**CITY OF SAINT PAUL  
HERITAGE PRESERVATION COMMISSION STAFF REPORT**

FILE NAME: 1008 Portland Avenue  
DATE OF APPLICATION: September 15, 2014  
APPLICANT: Jay Duggan, Duggan Construction  
OWNER: Joan Eggenberger  
DATE OF HEARING: October 9, 2014  
HPC SITE/DISTRICT: Hill Historic District  
CATEGORY: Contributing  
CLASSIFICATION: after-the-fact building permit  
STAFF INVESTIGATION AND REPORT: Christine Boulware  
DATE: October 1, 2014

PROPOSED RESIDE @ 1008 PORTLAND AVE ST PAUL

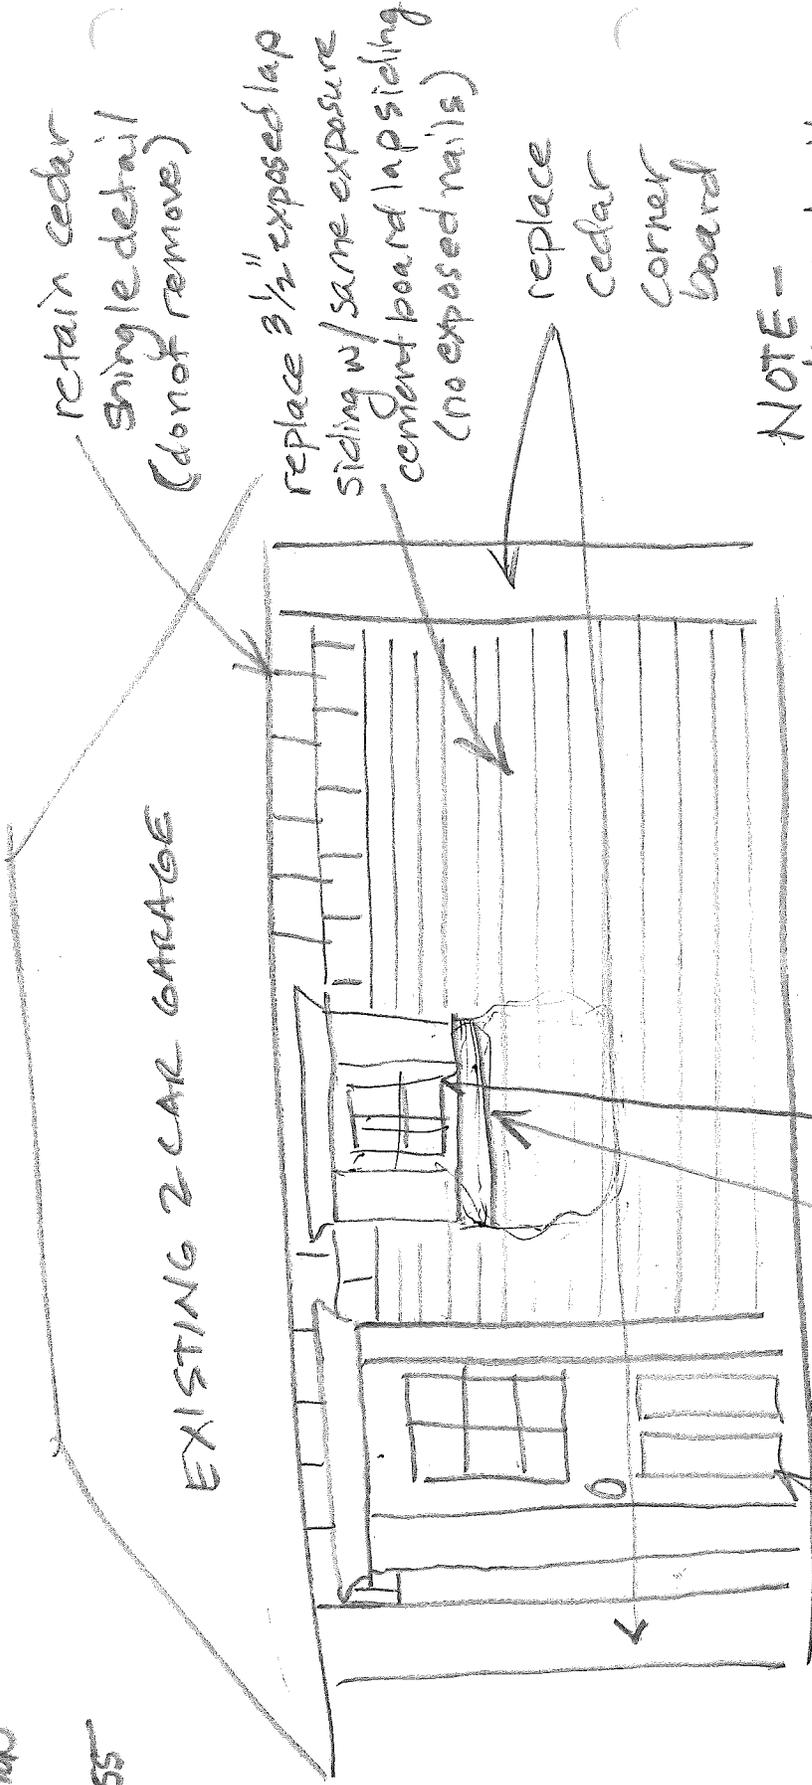
contractor owner has already thrown away 3 wood windows and bought vinyl windows has removed siding -  
 9/15 called PT Todd Sutter - stop work
